No. 1232
ATA Code 24-30

- SUBJECT:** ELECTRICAL POWER - IMPROVED ALTERNATOR FEED DIODE INSTALLATION
- EFFECTIVITY:** BEECHCRAFT Duchess 76, serials ME-1 through ME-342.
- REASON:** To reduce the possibility of the alternator feed diode shorting to the airframe.
- COMPLIANCE:** Beech Aircraft Corporation considers this to be a mandatory modification and it should be accomplished as soon as possible after receipt of these Service Instructions, but no later than the next 50 service hours.
- APPROVAL:** Engineering data contained in these Service Instructions is FAA approved.
- MANPOWER:** The following information is for planning purposes only:

Service Instructions No. 1232

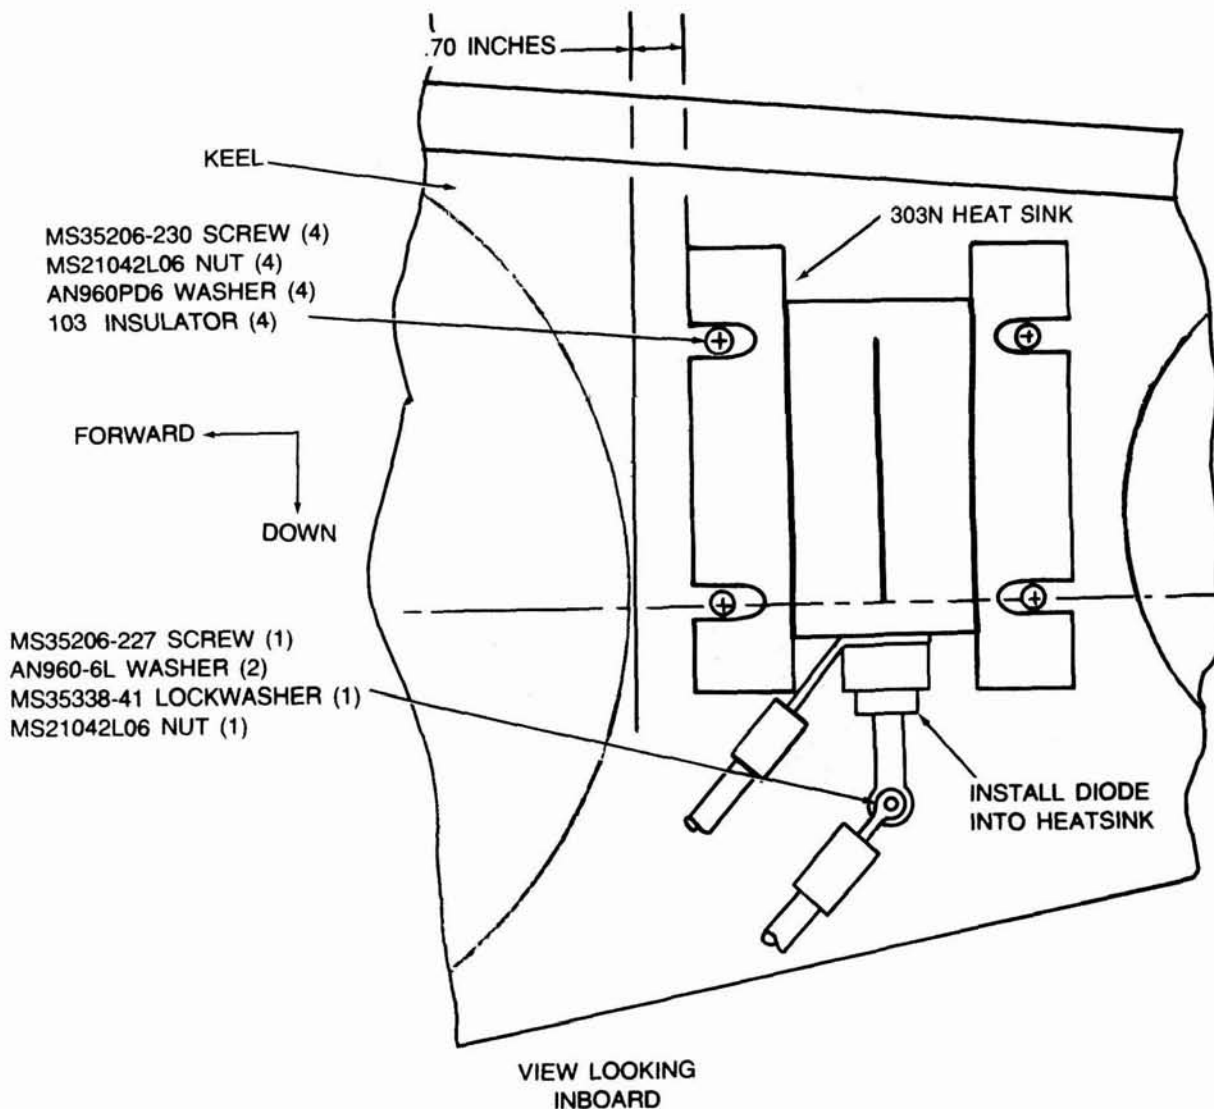
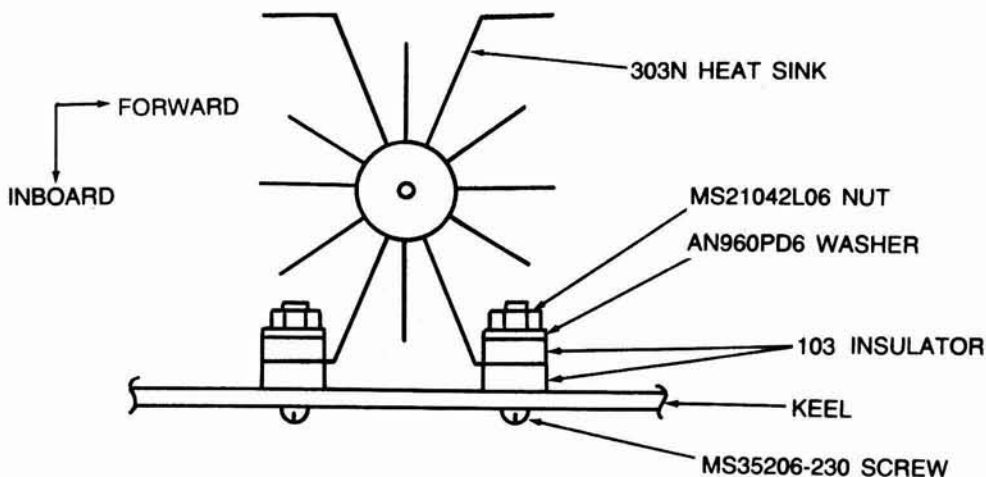
1. Turn off all electrical power and disconnect the battery.
2. Remove both upper aft nacelle access panels.
3. On either nacelle, disconnect the wires to the isolation diode, which is mounted through the inboard keel. Remove the diode and retain it for reinstallation. Discard the two insulation washers and teflon ring used to mount the diode in the keel.
4. Using a P/N 303N heat sink as a pattern, drill four .139/.148 inch diameter holes in the inboard keel. (see illustrations).
5. Mount the P/N 303N heat sink to the inboard keel using P/N 103 insulators, MS35206-230 screws, AN960PD6 washers and MS21042L06 nuts (see illustrations).

6. Reinstall the diode removed in Step 3 by threading it into the bottom end of the heat sink. Install the terminal on the end of wire P23A8 (LH nacelle) or P34A8 (RH nacelle) over the stud end of the diode before threading the diode into the heat sink. Coat both sides of the terminal with 120 Thermo-Joint Compound prior to installing the terminal.

7. Reinstall the wire which was removed in Step 3 on the diode terminal using a MS35206-227 screw,

two AN960-6L washers, a MS35338-41 lockwasher and MS21042L06 nut.

8. Using an ohmmeter (set on highest scale) check for infinite resistance between bare metal on the heat sink and bare metal on the keel. If continuity is present, the P/N 103 insulators must be replaced.
